Item No	Application and Parish	No.	8/13 Week Date	Proposal, Location and Applicant
(2)	17/02533/OUTD Newbury Town Council	13 <sup>th</sup> 2017	November	Outline application for erection of a single dwelling. Matters for consideration siting and scale other matters reserved.  Mr Barton  Land Adjacent To 4 Croft Lane, Newbury

**Recommendation Summary:**                    **The Head of Development and Planning be authorised to REFUSE the application.**

Highway Officer Comments:

Site Photo – Tree to the north

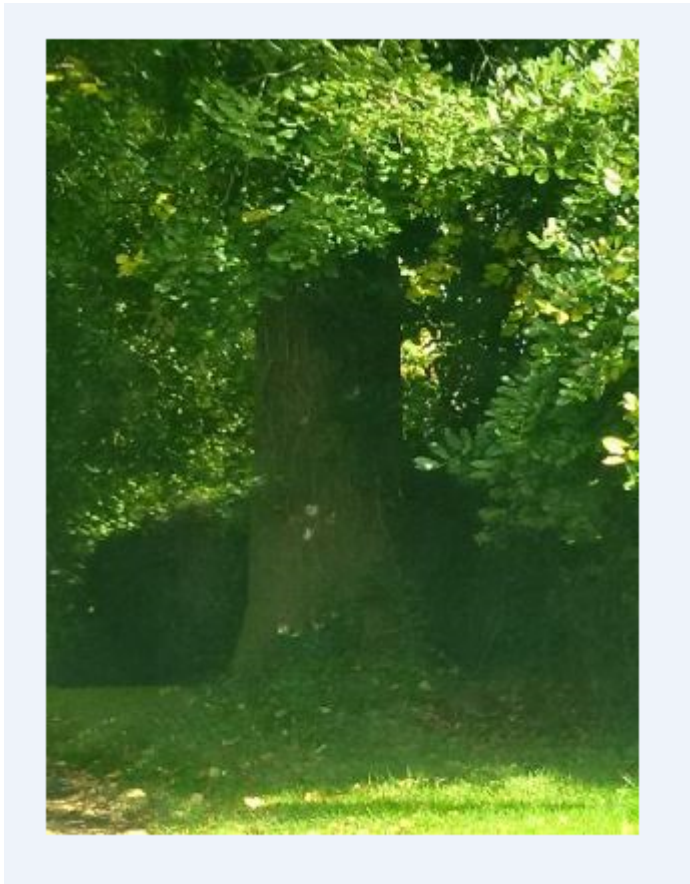
To the north of the access there is a wide tree trunk that obstructs the visibility splay in this direction. Whilst *Manual for Streets* accepts some obstructions such as telegraph poles, this tree trunk is much wider than this.

- 2\* metres by 24\*\* metres to the south to the nearside carriageway edge.
- 2\* metres by 22.5\*\* metres to the north to the nearside carriageway edge.

Although this is an outline application with all matters reserved, I am of the view that the above must be provided on a plan to identify whether it is achievable without obstructions – this includes the tree trunk currently within the splay to the north.

Site Photo – Vegetation to the south of the access

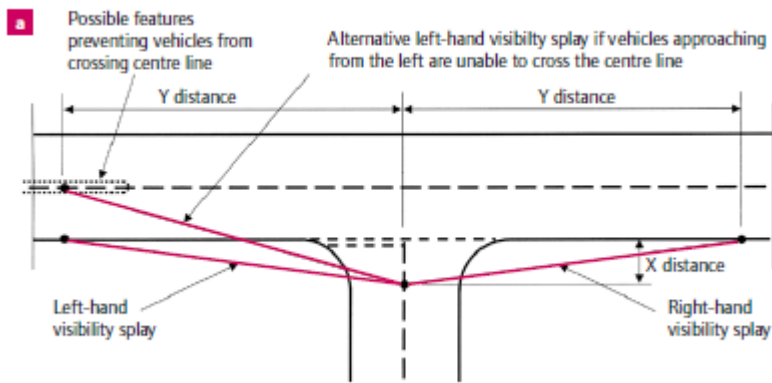
To the south, the achievable splay is approximately 5 metres to the nearside carriageway edge. This is significantly below the splay required in this direction – potentially 24 metres.

The reason for the sub-standard visibility splay to the south is existing vegetation. In the photograph below, the vegetation is within the foreground, with the proposed access from the grassed area behind.

The photograph demonstrates that this vegetation presents a significant obstruction to visibility and a vehicle exiting the access would need to protrude out into the carriageway before the driver would be able to see whether there was a vehicle approaching from the south. I have received confirmation that the highway boundary extends across the width of the lane to the property frontages. Technically therefore, this vegetation is within the public highway, although not maintainable at public expense.
